LEE'S SUMMIT MIDDLE SCHOOL #4
LEE'S SUMMIT R-7 SCHOOL DISTRICT
1001 SE BAILEY ROAD
LEE'S SUMMIT, MO 64881

PACKAGE 2 - STRUCTURAL & SITE UTILITIES
ISSUED FOR PERMIT
08/28/20

PR002R 01.14.21
CPR 1 12.16.21
ASI-40 02.10.22

STANDARD DETAILS

WATER METER VAULT DETAIL
NOT TO SCALE

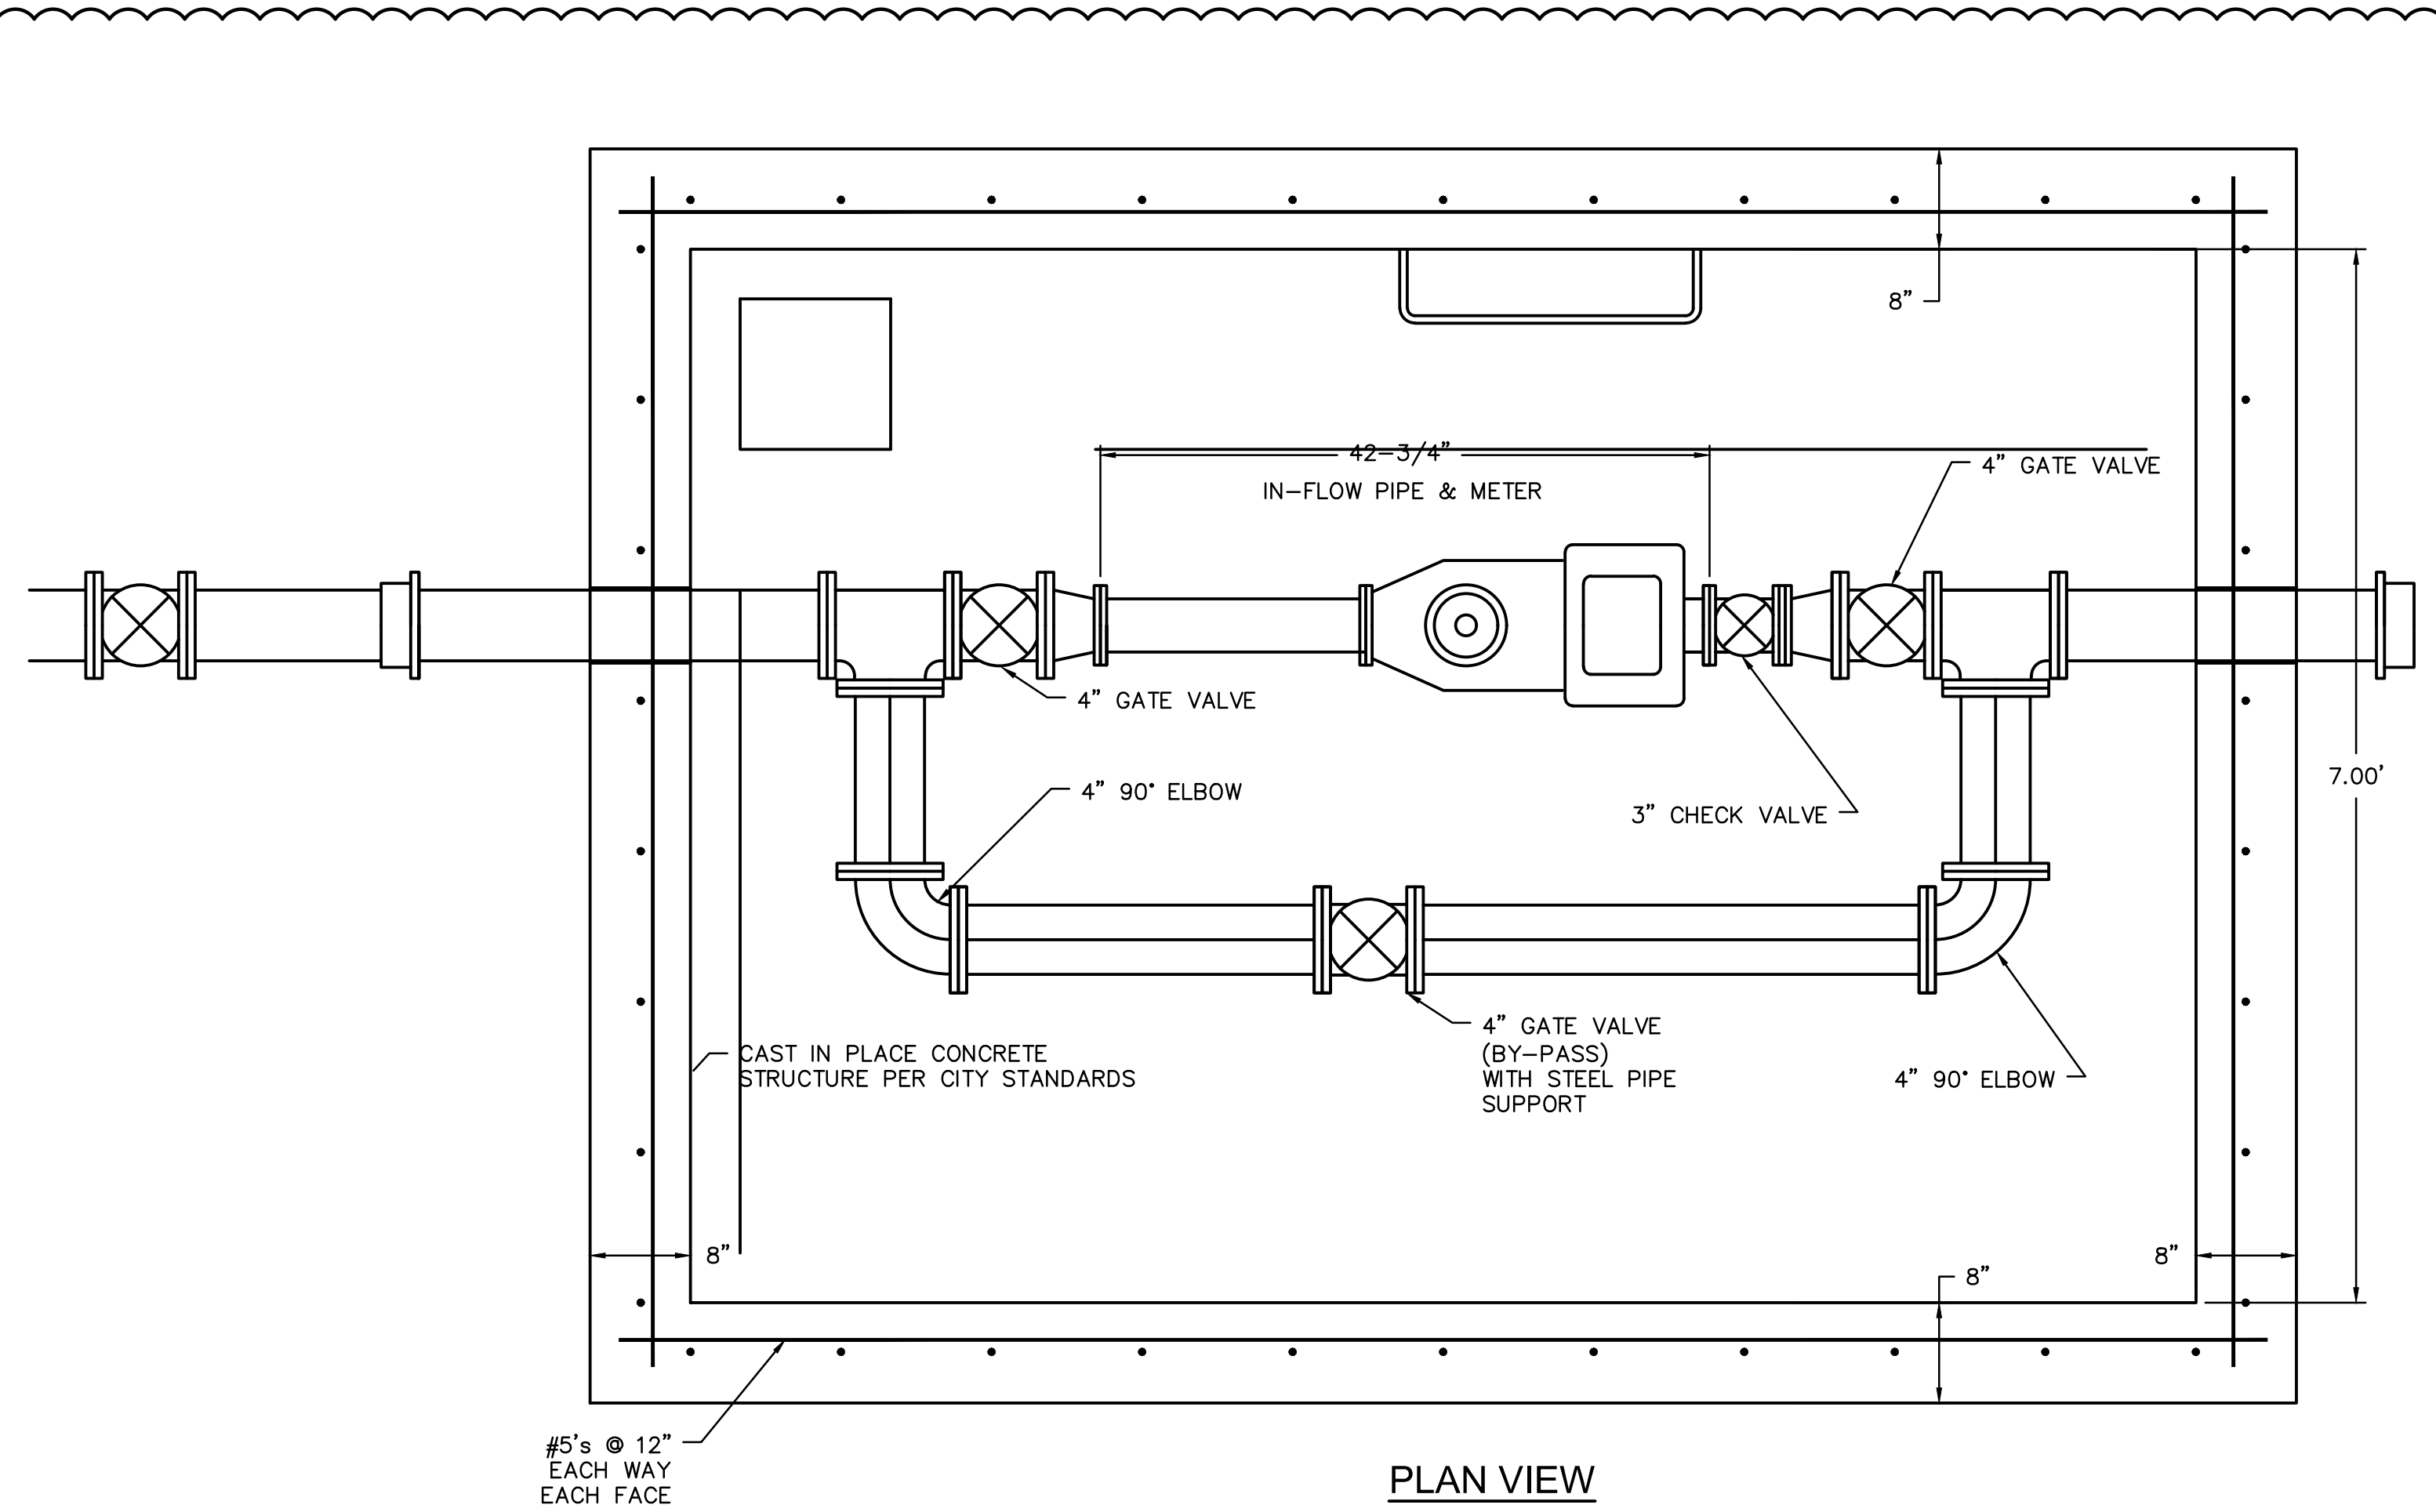
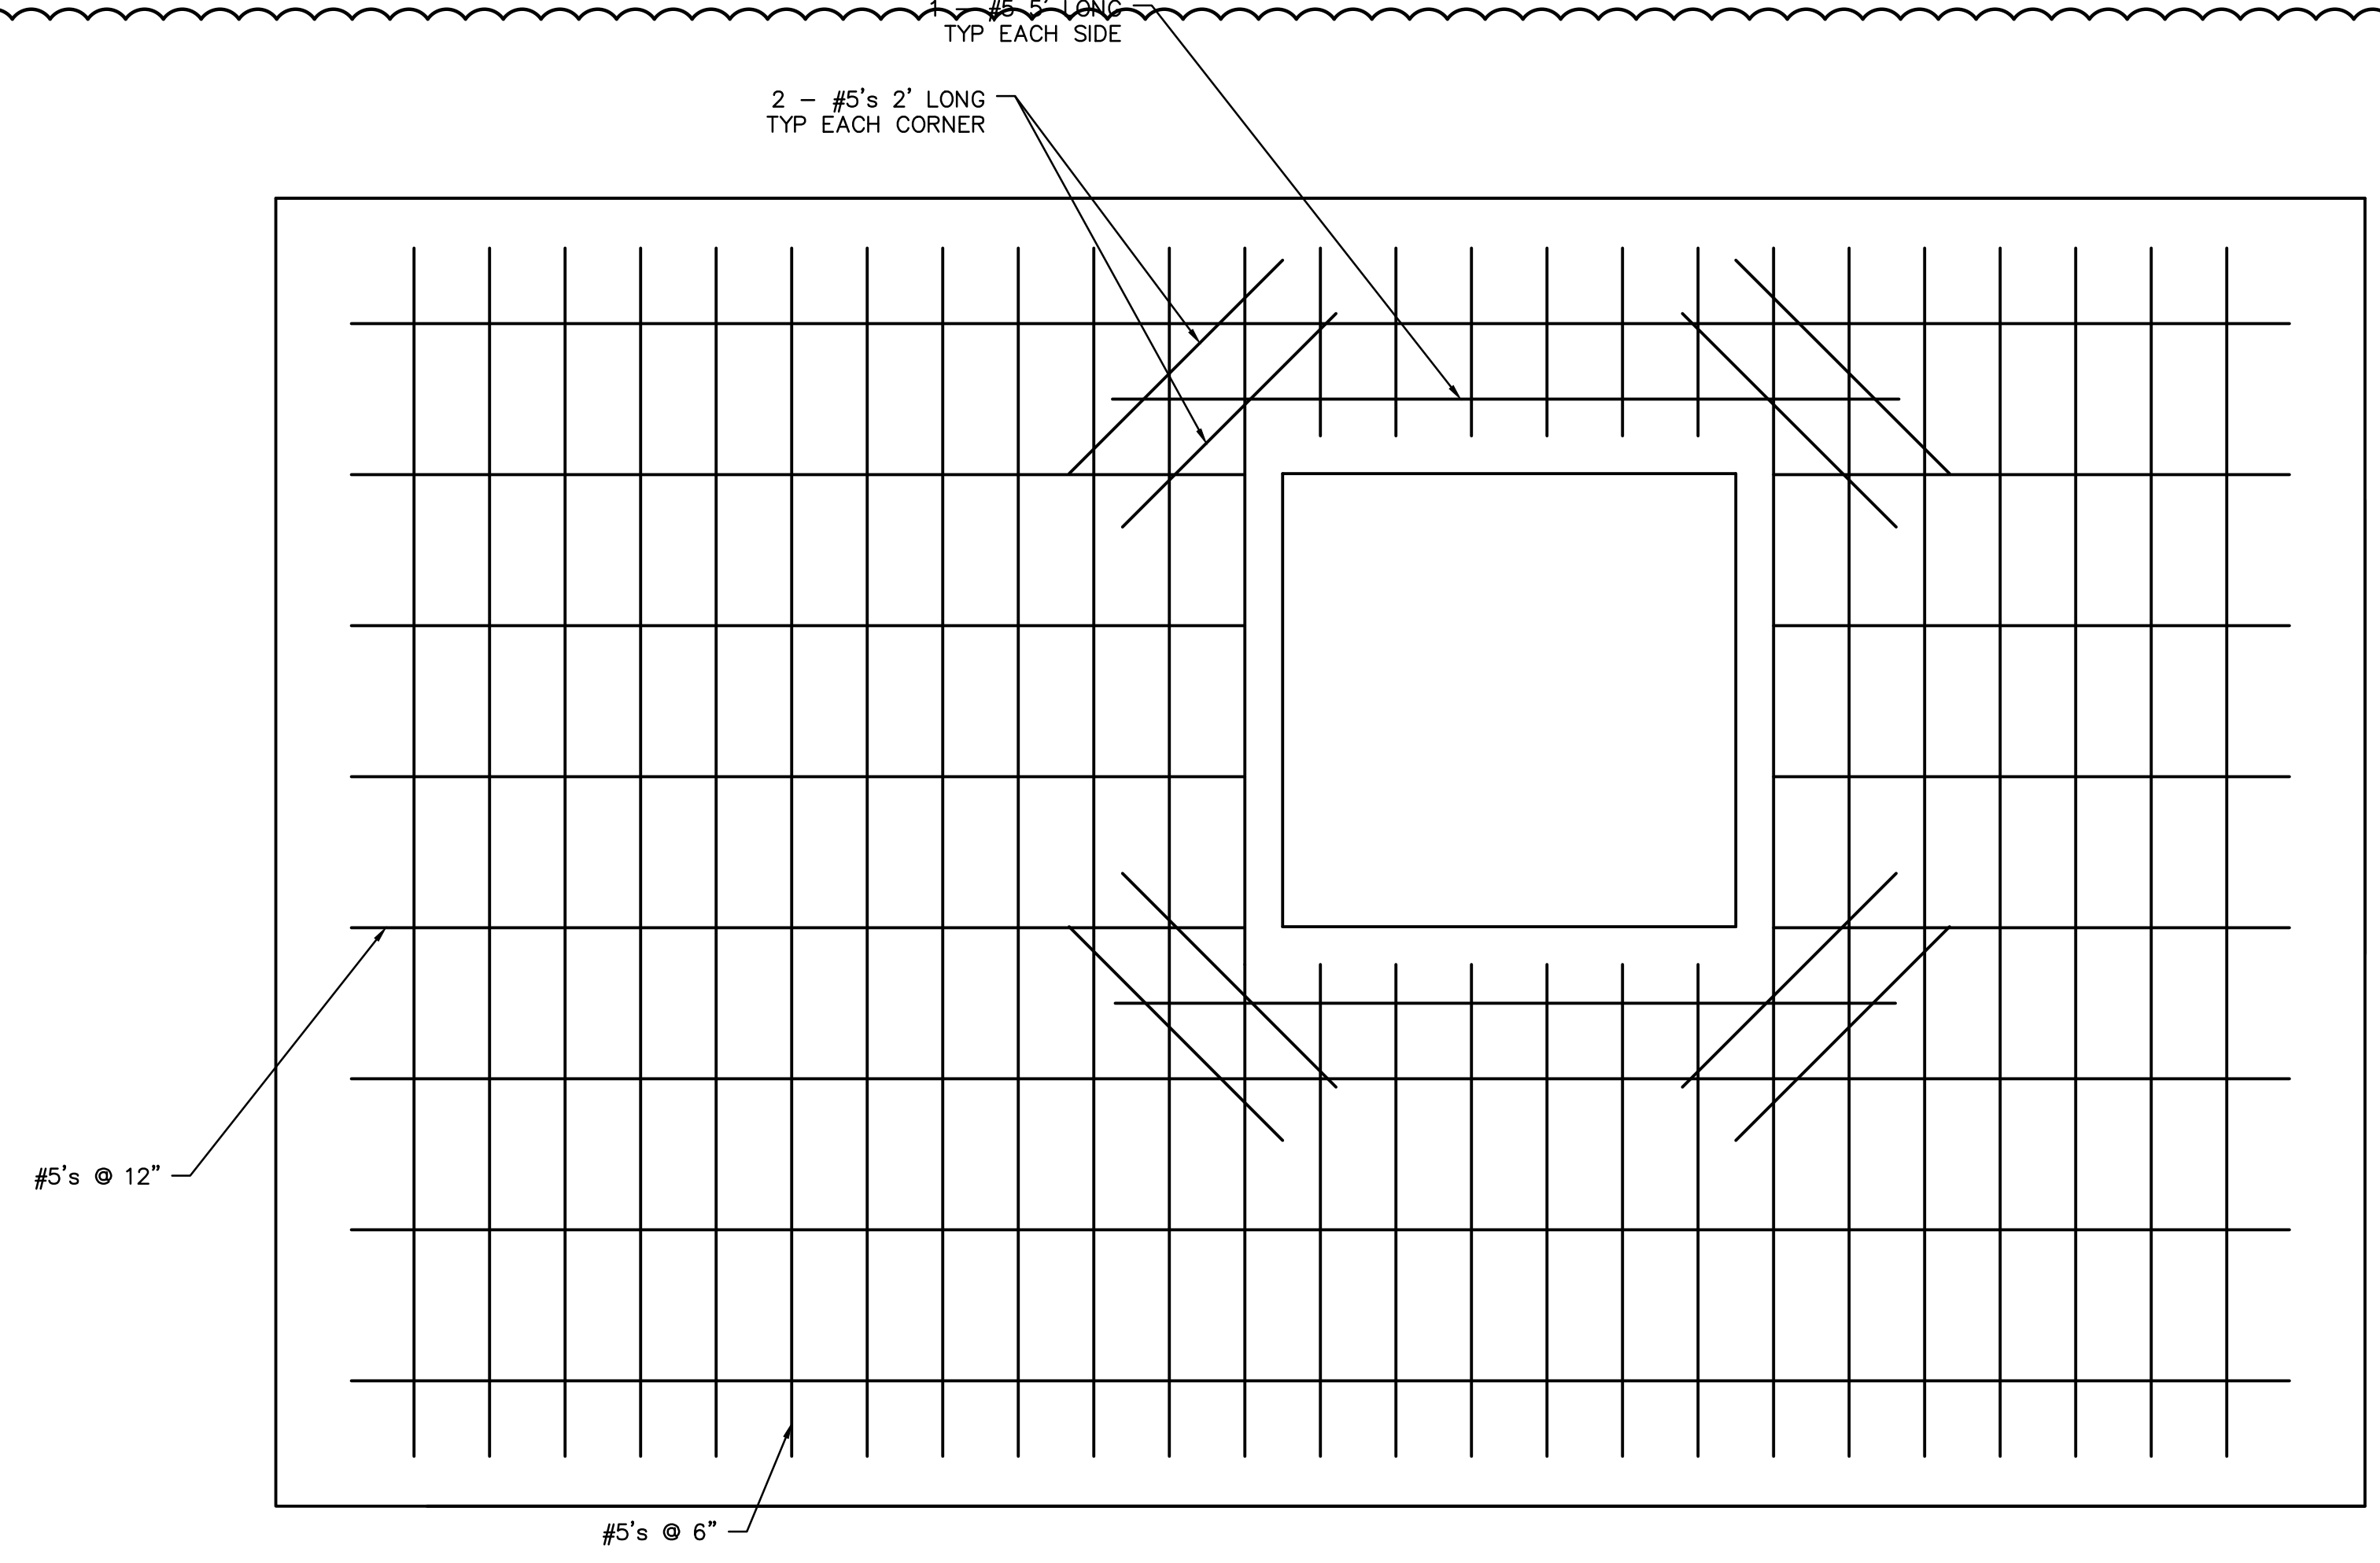
MOVED WATER VAULT DETAILS TO C1050A
